VERMONT YANKEE NUCLEAR POWER CORPORATION

B.3.2.1
WVY-80-123

Subject: Hydrogen Monitoring System

HYDROGEN
MONITORING
SYSTEM

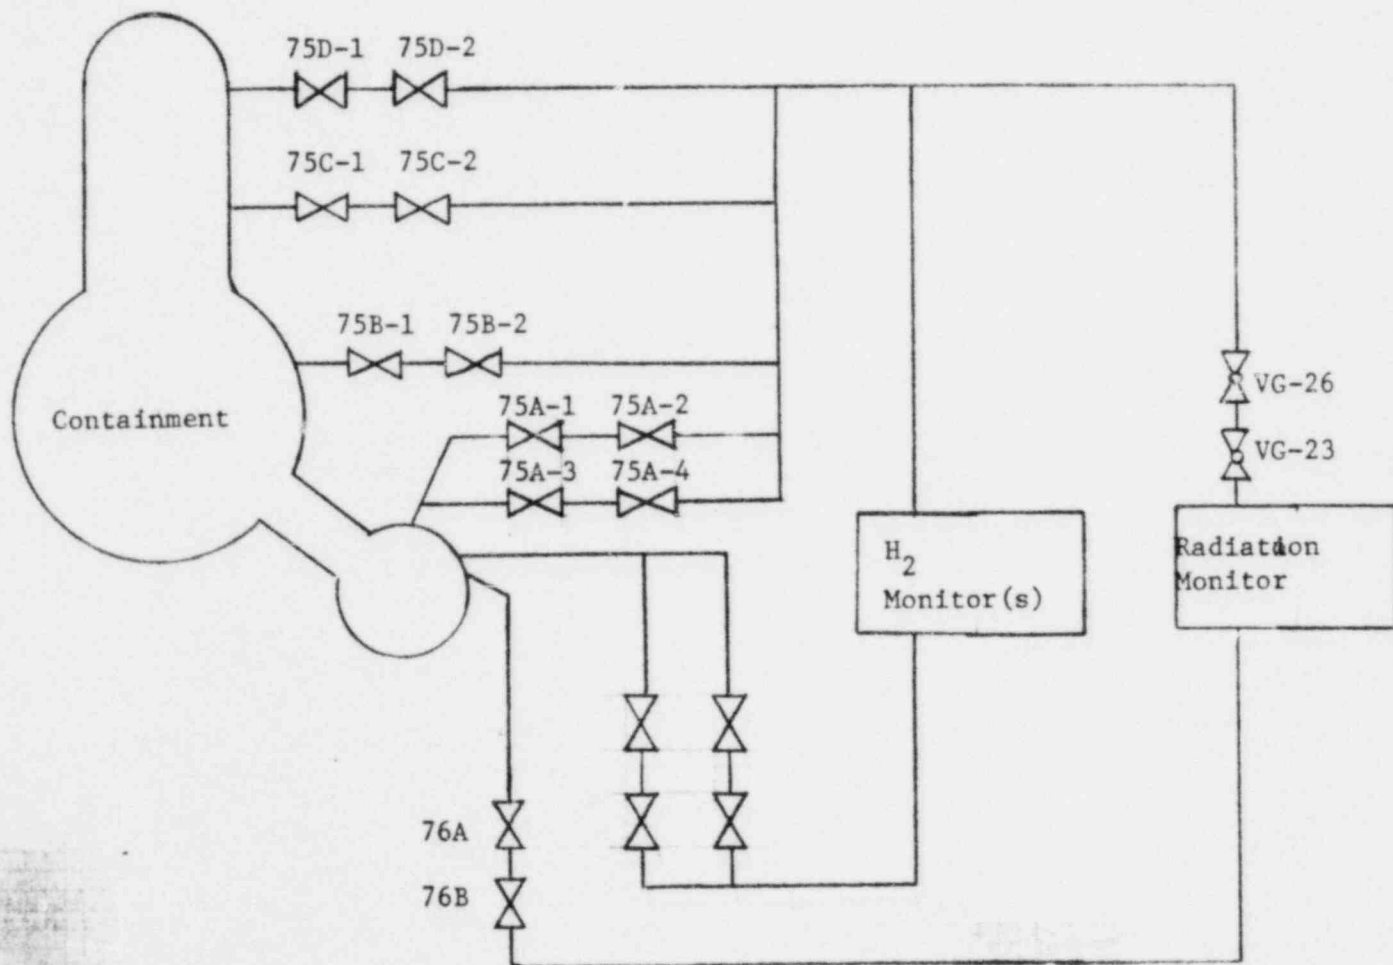
Delete "Containment Air Sampling System" valves 109-75A-D; 1&2 and 109-76A & B from Technical Specification Table 4.7.2b. Add valves VG-23, VG-26, 109-76A & B to Technical Specification Table 4.7.2a.

109-75A-D; 1&2. However, the hydrogen monitoring subsystem was designed and installed to be an integral part of the containment and as such does not require a system isolation. A second line, which branches off the sample inlet header goes to a radiation monitor. Solenoid valves VG23, VG26 and 109-76A&B were installed in the radiation monitor inlet and outlet lines to close on receipt of a primary containment isolation signal and provide containment isolation. A sketch is attached to illustrate this arrangement.
